MIL-C-5809G
AMENDMENT 1
23 September 1992

MILITARY SPECIFICATION

CIRCUIT BREAKERS, TRIP-FREE, AIRCRAFT,
GENERAL SPECIFICATION FOR

This amendment forms a part of MIL-C-5809G, dated 30 November 1987, and is approved for use by all Departments and Agencies of the Department of Defense.

FIGURE 2a. Sample fixture.

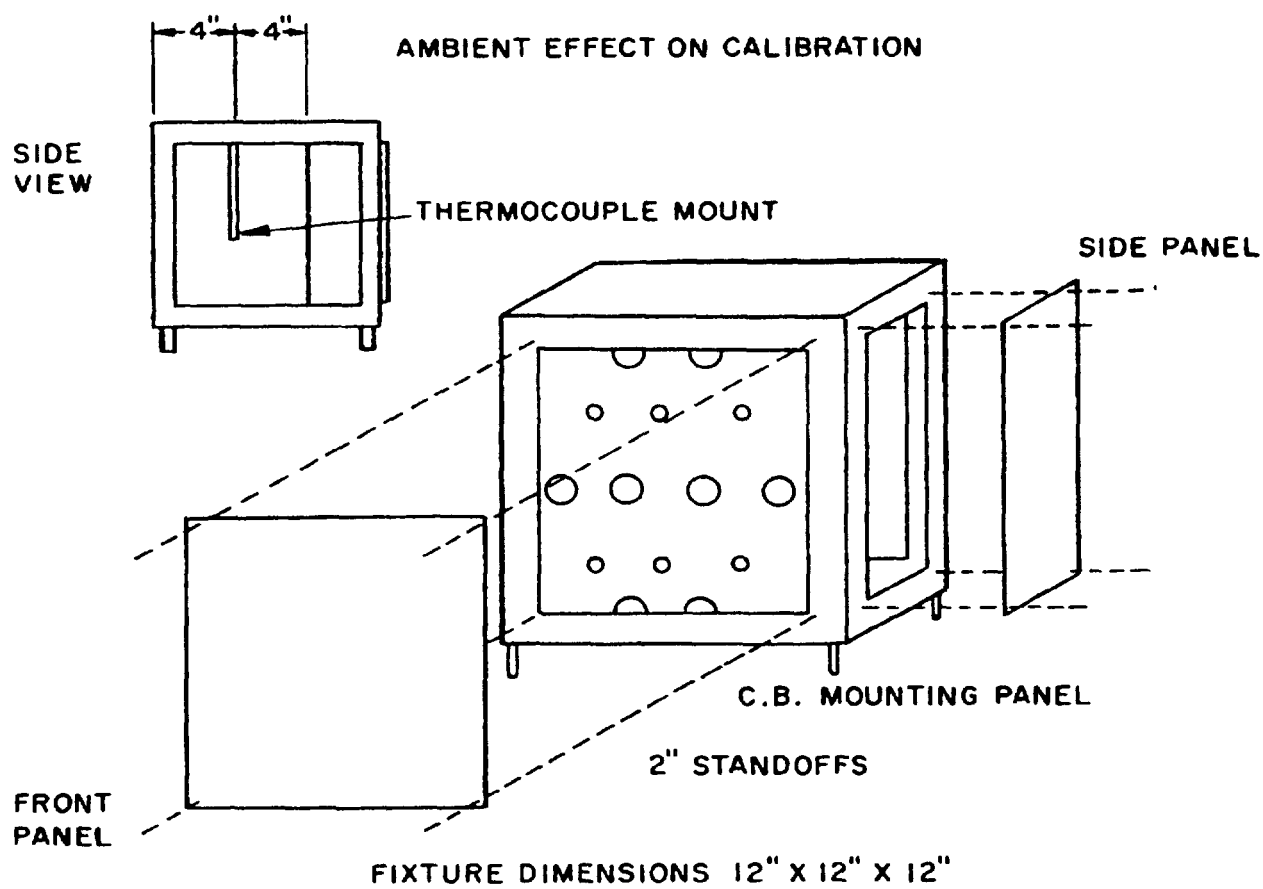
"4.7.7.5.1 Still air environment. Still air environment is the area surrounding the circuit breakers within a given chamber where any reduction in air velocity within the area of the circuit breakers would cause a maximum 2°C rise in temperature. The still air environment for temperature chambers 4 cubic feet and larger shall be obtained by using the fixture shown on figure 2a. Fixture dimensions are shown on figures 2b and 2c. The test fixture shall be placed in the temperature chamber so that the rear lead port of the fixture is facing away from the direct air flow created by the chamber circulating fan. A typical installation is shown on figure 2d. The distance of the rear lead port from the chamber wall shall be determined by first placing a fully loaded fixture beginning at 1 inch from the chamber wall and performing the minimum limit of ultimate trip test at both extremes of temperature. The temperature rise inside the fixture shall be monitored during the test. If the internal temperature exceeds the 2°C limit, the test shall be stopped and the fixture moved away from the chamber wall in small increments until the fixture internal temperature maintains the temperature gradient of +2°C within the area of the circuit breakers. During the performance of all calibration tests, a minimum of 18 inches of lead length shall be kept inside the chamber to cancel any of the effects of heat conduction from the circuit breakers through the leads. Room ambient tests shall be performed inside a temperature chamber set at 25°C. Alternate means of obtaining the still air environment must be approved by the Qualifying Activity."

For chambers that are less than 4 cubic feet in volume, the fixture dimensions stated for the chambers that are 4 cubic feet and larger can be modified and the number of circuit breakers that can be tested at one time can be reduced in order to meet the still air requirements."

After 4.7.7.5.1, insert the attached figures 2a through 2d.
